Augeas Corporation

**Re: Groundwater and Soil Contamination Assessment Workplan - Veterans Affairs
Medical Center - Livermore, California**

FIGURE 3
SITE PLAN-

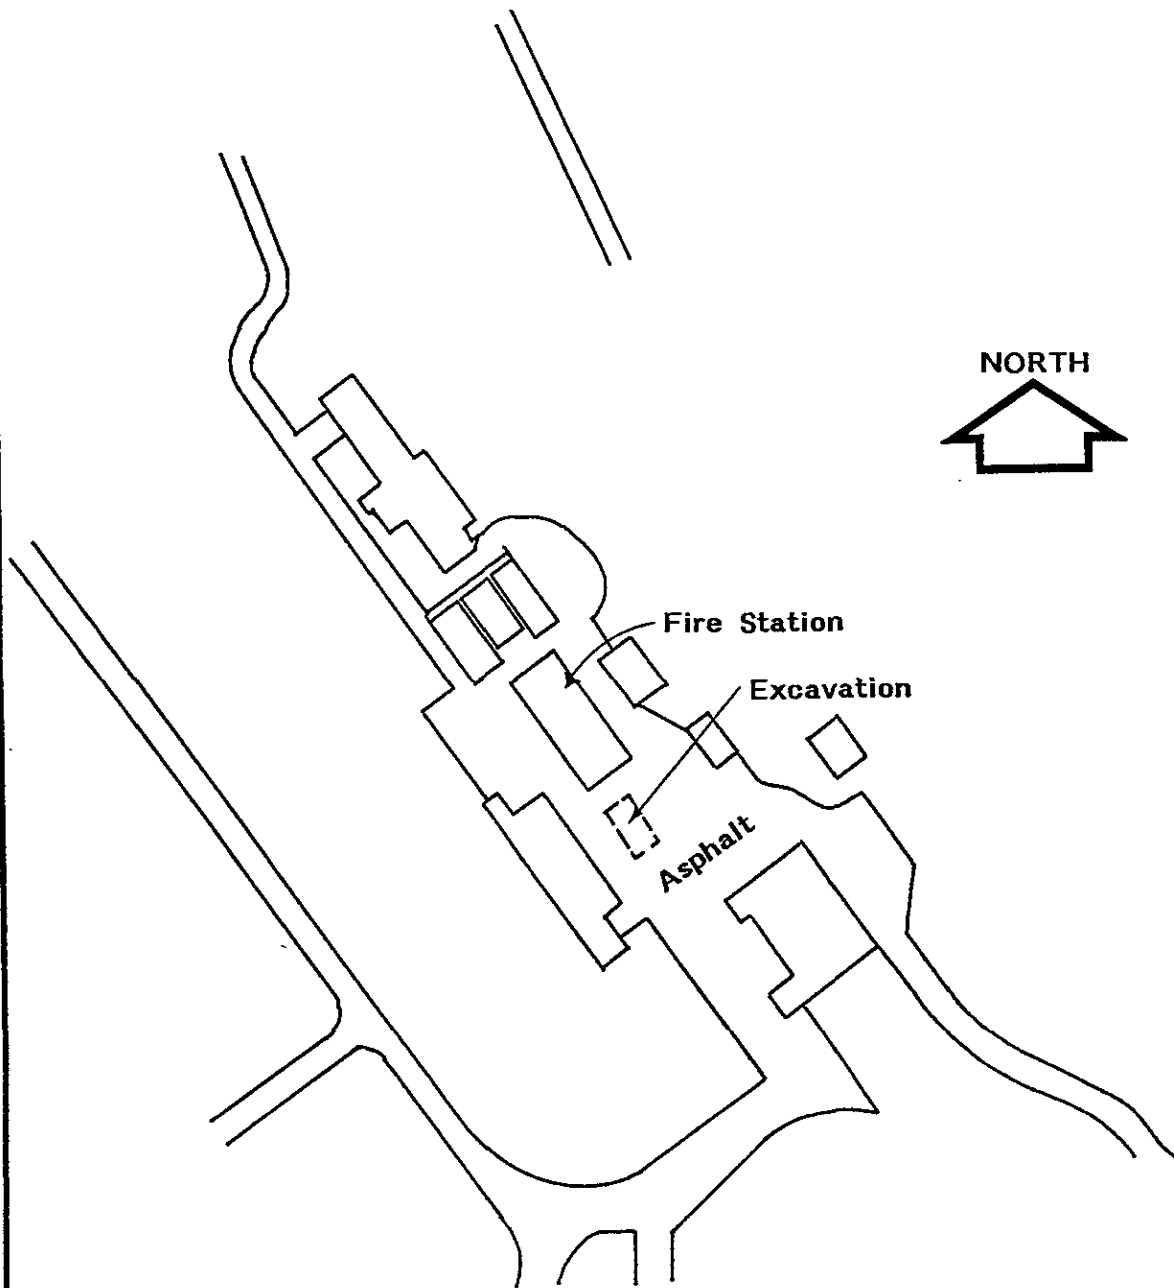
no!
not
marked

WELL COMPLETION DETAIL

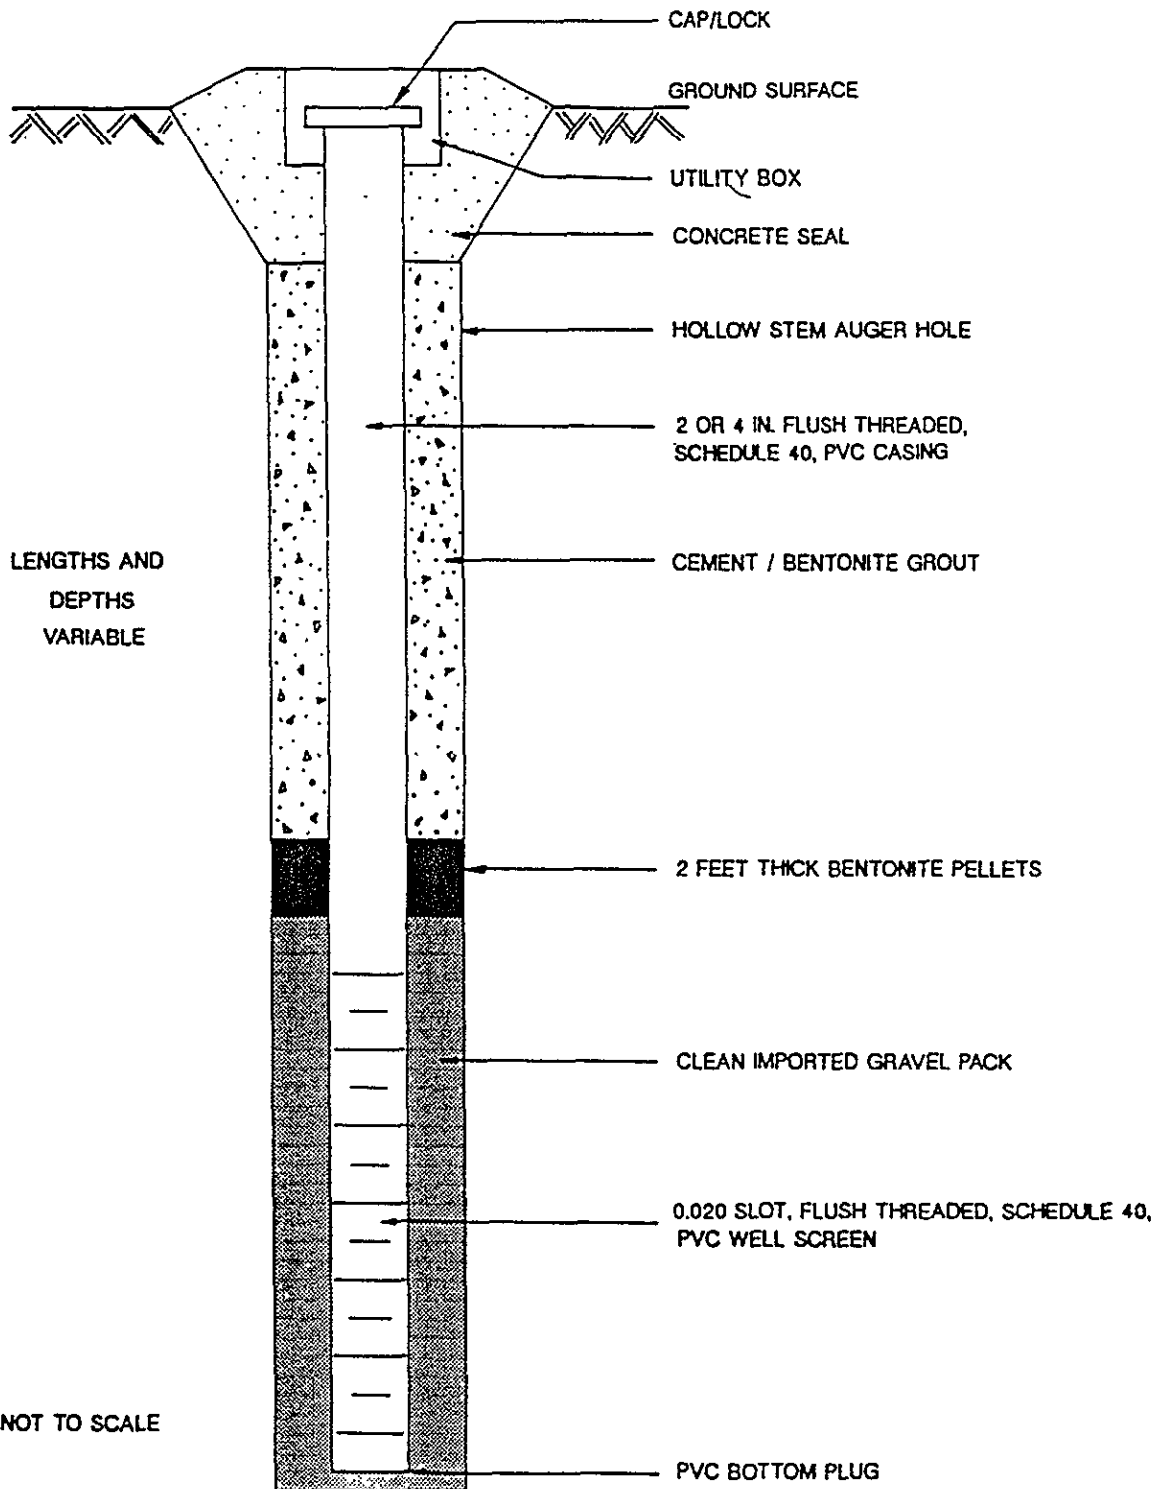
?
